Site Accessibility Evaluation

Americans with Disabilities Act Title II (Public Services: State and Local Government)

EPC Veteran Services

**5850 Championship View
Colorado Springs, CO
80922**

Finding: 1

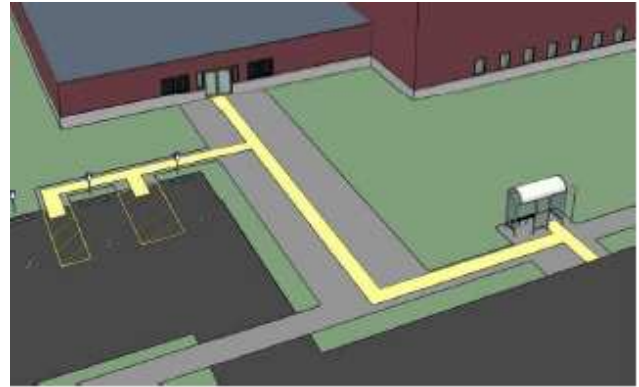
The accessible parking is not located on an accessible route of travel to the accessible building entrance.

**No accessible
pedestrian ramp or
access aisle exists**

Move the existing accessible parking stall and access aisle 3 to 4 stalls over (north). The cross slope of that section of the parking lot is compliant or very close to meeting the 2% maximum. The running slope will have to be addressed as it currently exceeds the 2% maximum and is somewhere between 4 to 5%.

- It will require new asphalt/concrete and grading but it is easily achievable due to the minimal grade/slope of that section of the parking lot.

- Additionally, a parallel pedestrian ramp will be required to grant access to the sidewalk for wheelchair users thus allowing entrance to the veterans office. Parallel pedestrian ramp will have to be constructed and connect to the existing sidewalk

Finding: 2

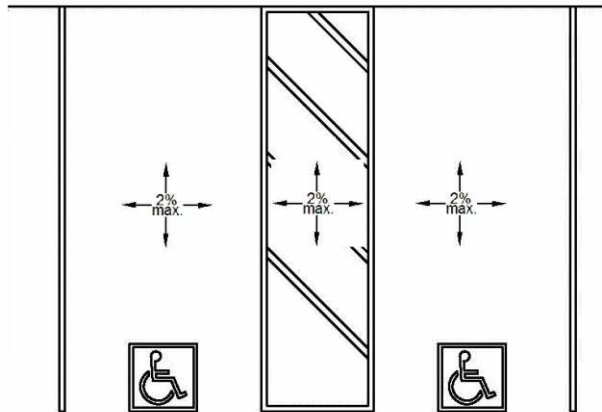
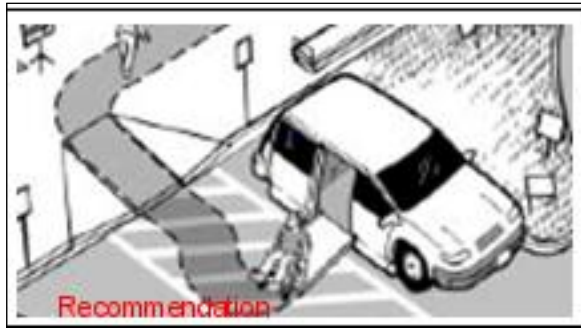
The accessible parking stall's access aisle contains a built up curb ramp which results in significant slopes greater than 2 percent.

Asphalt ramp
protruding into
parking access aisle
with a running slope of
12.3%

Remove protruding ramp and design/construct parallel curb ramp into existing sidewalk not to exceed 8.33% running slope and 2% cross slope. Note: that this property is a lease, and the landlord is responsible for the correction.

Finding: 3

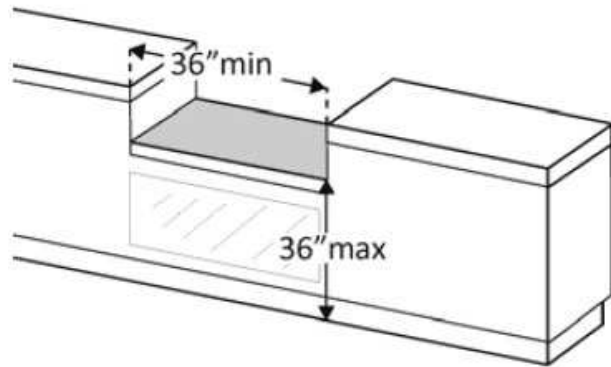
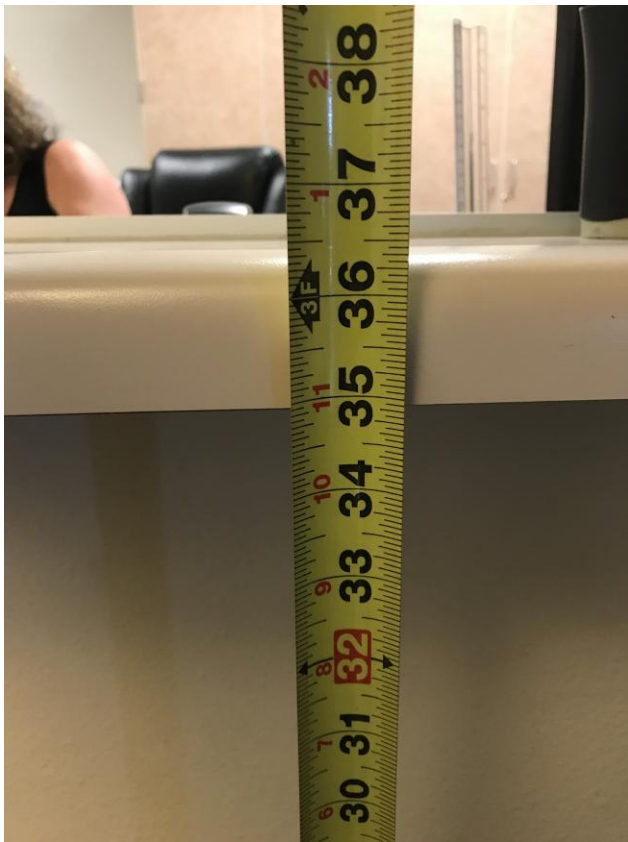
The transaction counter is too high.

**36.25 inches above
finished floor**

Replace or re-configure a section of the transaction counter to provide a clearance of 36 inches high and a minimum of 36 inches wide.

Finding: 4

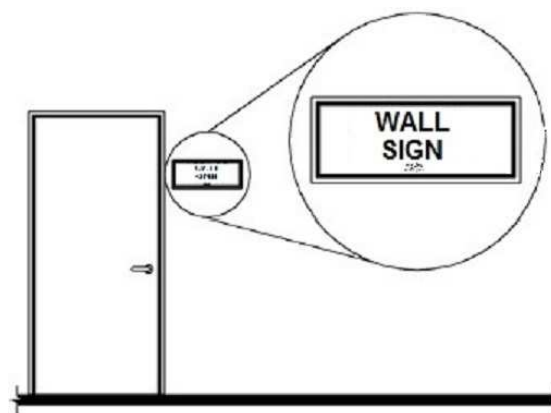
The tactile sign is incorrectly located.

Located on door.
Submit w/o to relocate sign.

Submit a work order to have sign reinstalled.

Corrective Action: W/O 386286 submitted. Relocated sign on 4/03/2017.

Finding: 6

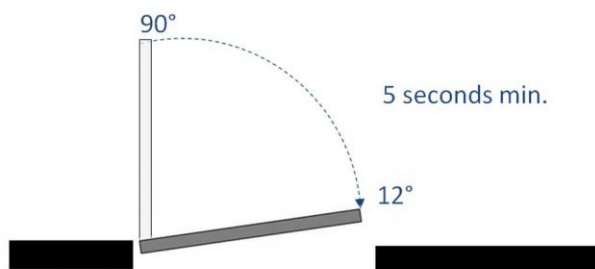
The door is equipped with a door closer and returns to a closed position too quickly.

Closer takes 3.8 seconds to close.

Submit work order to have door closer adjusted.

Corrective Action: W/O 381234 completed 2/1/2017.

Finding: 7

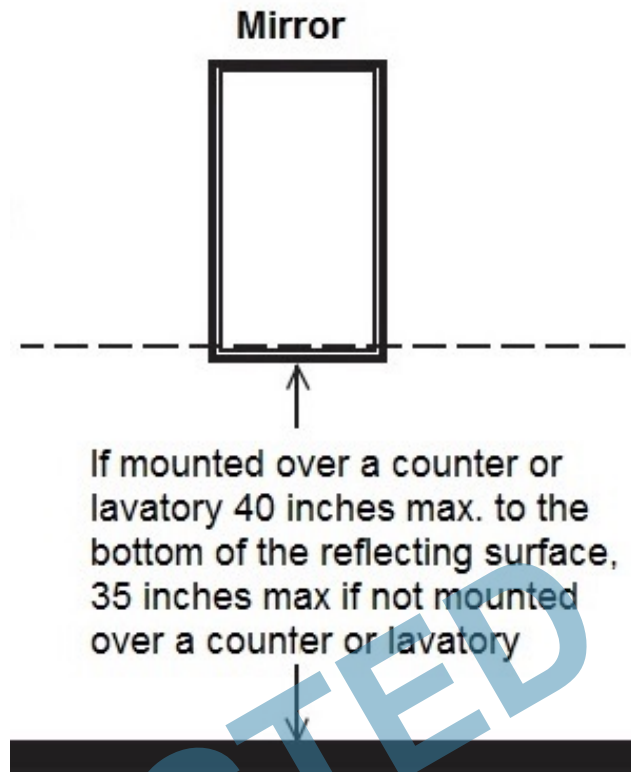
The mirror is mounted too high.

Mounted at 43 inches
above finished floor

Submit work order to have mirror lowered to 40 inches.

Corrective Action: W/O 381233 submitted. Completed 4/6/17. Mirror added to right side of lavatory with bottom edge of the reflecting surface at 35 inches above finished floor. Verified on 8/7/19

Finding: 8

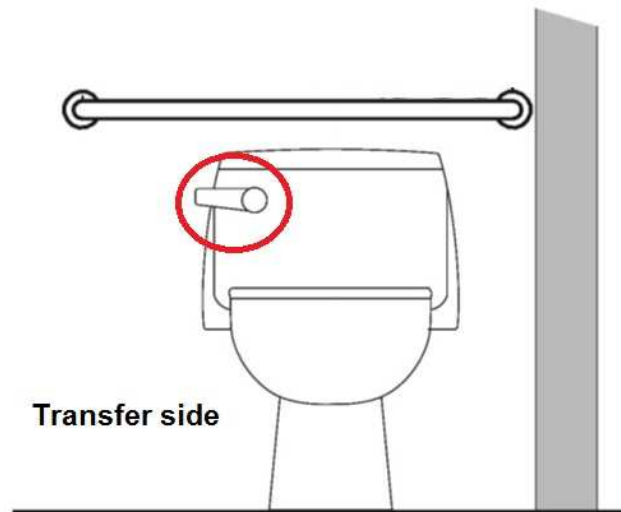
The flush handle is located on the wrong side of the toilet.

Flush control located
on closed side.

Submit a work order to move flush control to open side.

Corrective Action: W/O 381232 submitted. Installed new tank w/ handle on left side-completed 3/7/2017.

Finding: 9

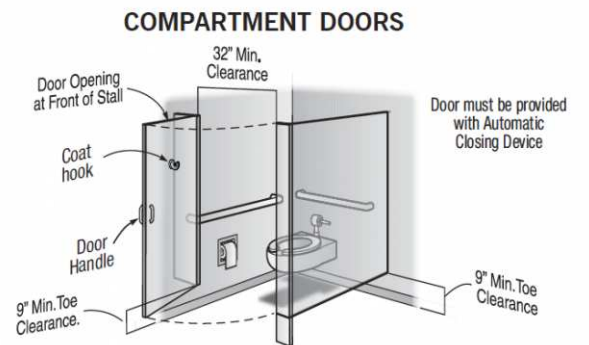
The compartment door is not self closing.

Stall door does not self-close.

Submit a work order to replace or adjust existing door closer.

Corrective Action: W/O 381231 submitted.

Finding: 10

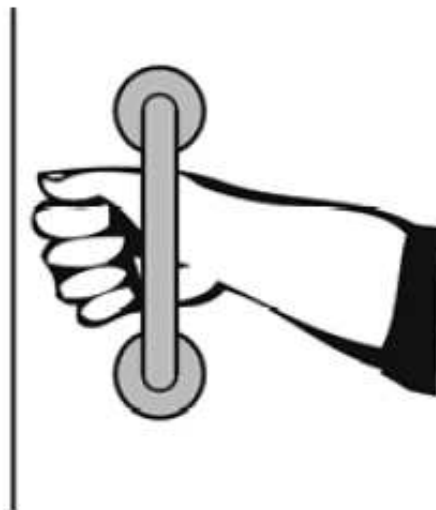
The water closet compartment door is missing a loop handle.

No loop handles installed.

Submit a work order to have loop handles installed on stall door.

Corrective Action: W/O 381230 submitted. Corrected 2/1/2017.

Finding: 11

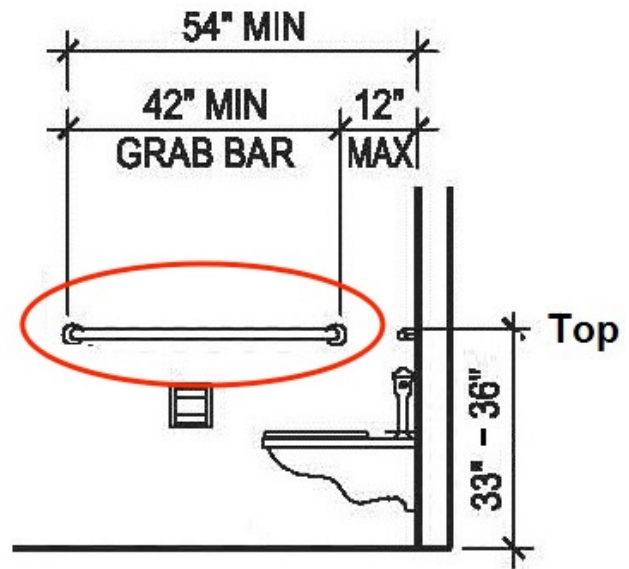
The side grab bar is too high.

36.75 inches above
finished floor

Lower side grab bar 1 inch to meet compliance.

Finding: 12

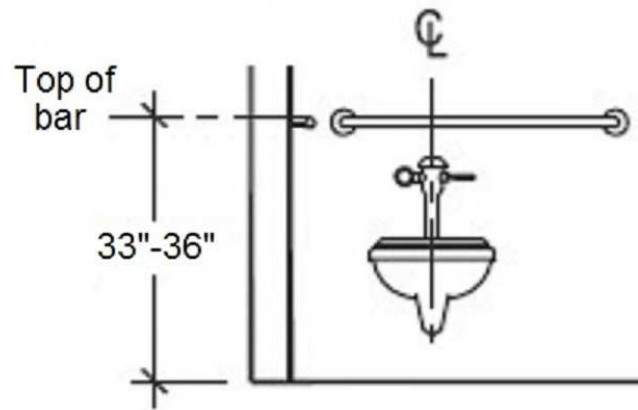
The rear grab bar is too high.

37 inches above
finished floor

Lower rear grab bar 1 inch minimum to meet compliance.

Finding: 13

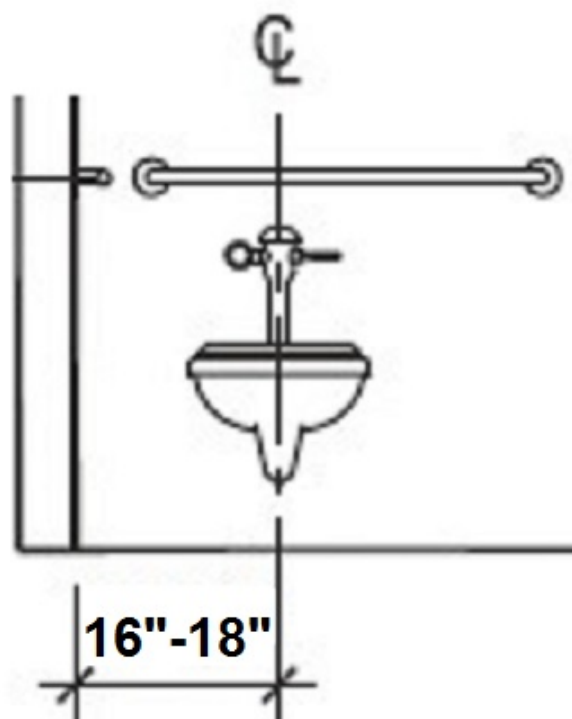
The toilet is not located within the range allowed from the side wall or partition.

19.25 inches from side wall

Adjust toilet so that is measures between 16 and 18 inches measured from the side wall to the centerline of the toilet.

Finding: 14

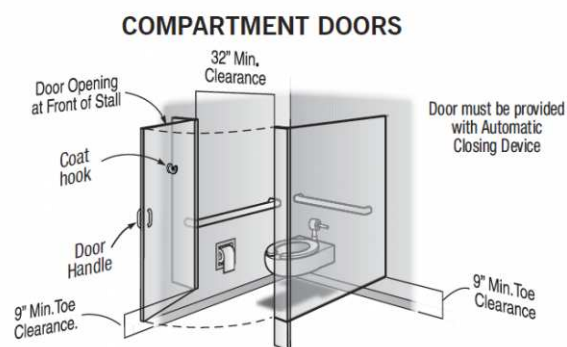
The compartment door is not self closing.

Stall door not self closing

Install or adjust compartment door hinges to make compartment door self close.

Finding: 15

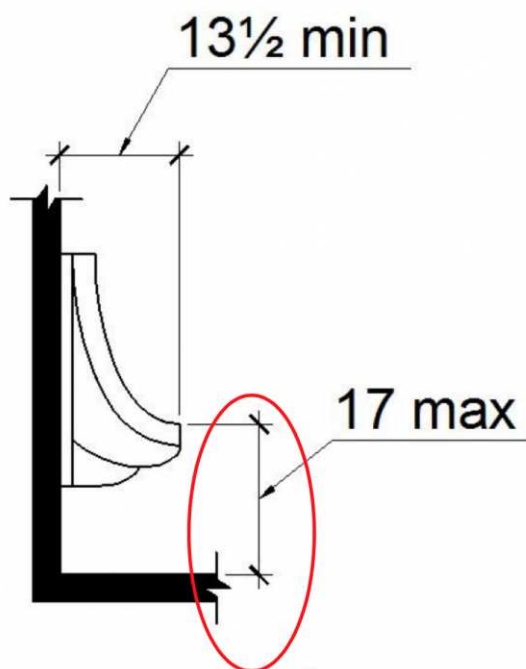
The rim of the urinal is too high.

23 inches above
finished floor

Lower urinal a minimum of 6 inches to ensure a 17 inch maximum height above finished floor.

Finding: 16

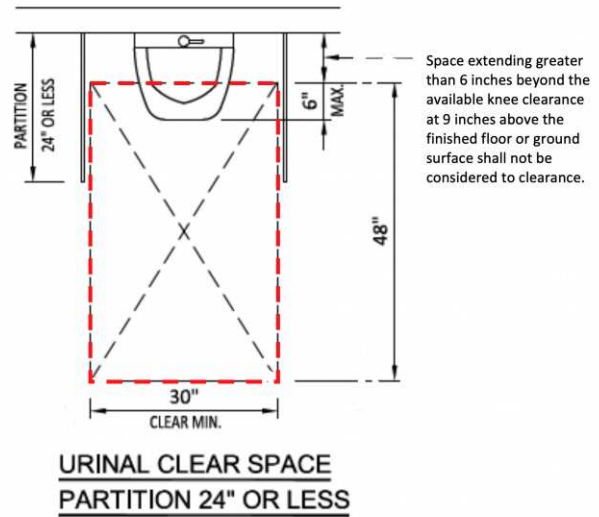
The urinal is located in an area that does not provide the required clear floor space for a front approach.

12.25 inches from
nearest side wall

Re-position right side wall partition to provide a an additional 2 inches in width if the the left side wall partition is unable to provide 3 inches due to the required clear floor space of 60 inches needed at the water closet. The additional 2 inches will provide the required 30 inch width minimum required. Note that urinal will not be centered to the required clear floor space.

Finding: 17

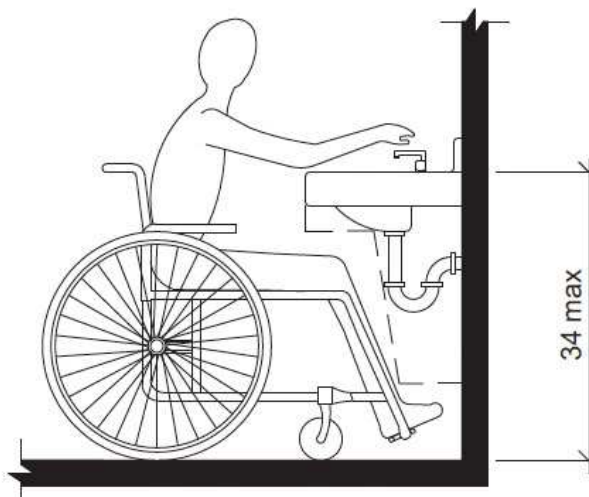
The top rim of the lavatory is too high.

34.25 inches above
finished floor

Lower lavatory by a minimum of .5 inches to ensure top rim of lavatory does not exceed 34 inches above finished floor.

Finding: 18

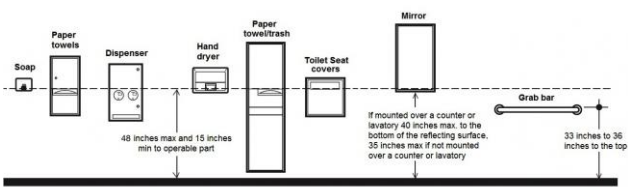
The paper towel dispenser's operation mechanism is too high off the floor.

49 inches above
finished floor

Lower paper towel dispenser a minimum of 2 inches. Operable parts should be at 48 inches maximum above finished floor.

Finding: 19

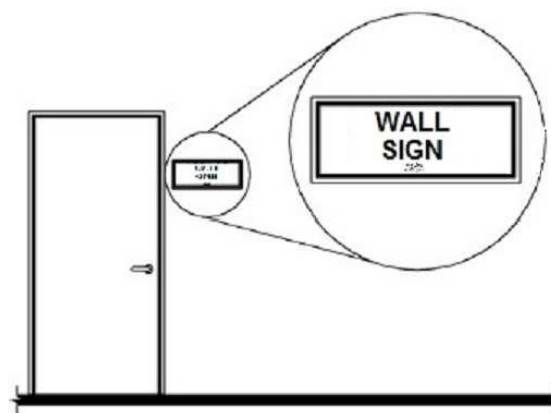
The tactile sign is incorrectly located.

Located on door.

Submit work order to relocate sign.

Corrective Action: W/O 386080 submitted on 1/26/2017.

Finding: 21

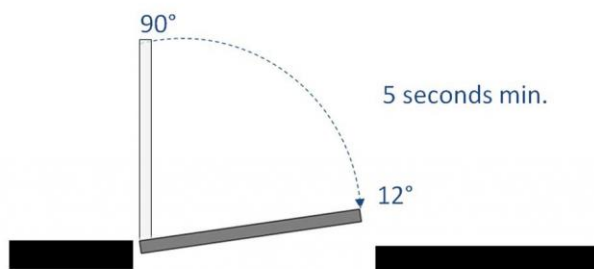
The door is equipped with a door closer and returns to a closed position too quickly.

Closer takes 2.7 seconds to close.

Submit a work order to adjust closer.

Corrective Action: W/O 381228 completed 02/01/2017.

Finding: 22

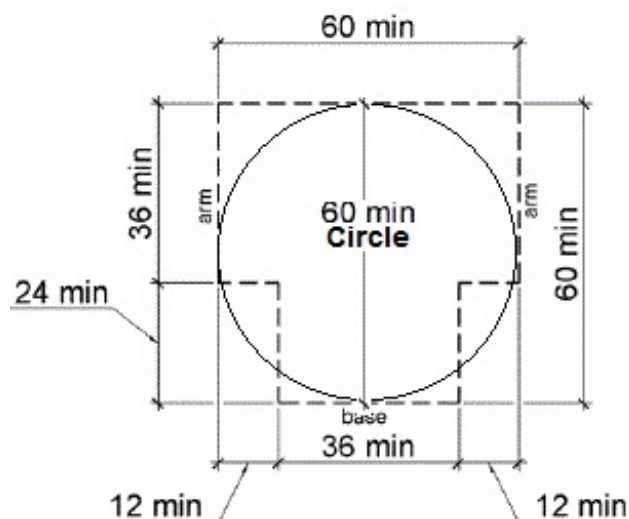
The restroom contains storage items and/or supplies which obstruct the clear floor and/or turning space within the restroom.

Measures 38 inches.

Submit a work order to have plan for budget and corrective action.

Corrective Action: W/O 381227 submitted. Corrected 2/1/2017.

Finding: 23

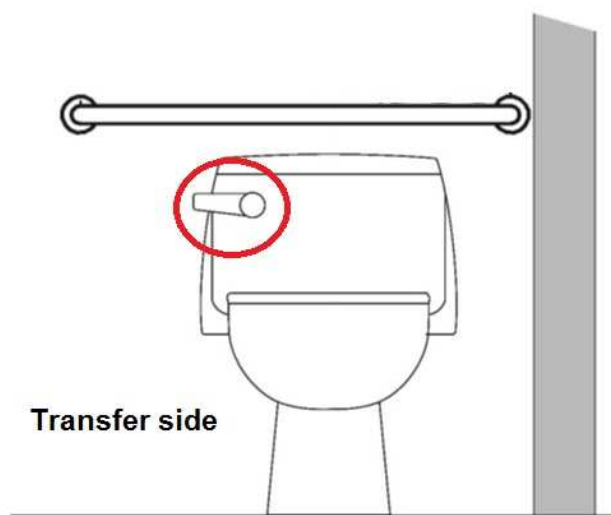
The flush handle is located on the wrong side of the toilet.

Flush control on closed side.

Submit a work order to move flush control to open side.

Corrective Action: W/O 381225 submitted. Installed new tank w/ handle on left side-completed 3/14/2017.
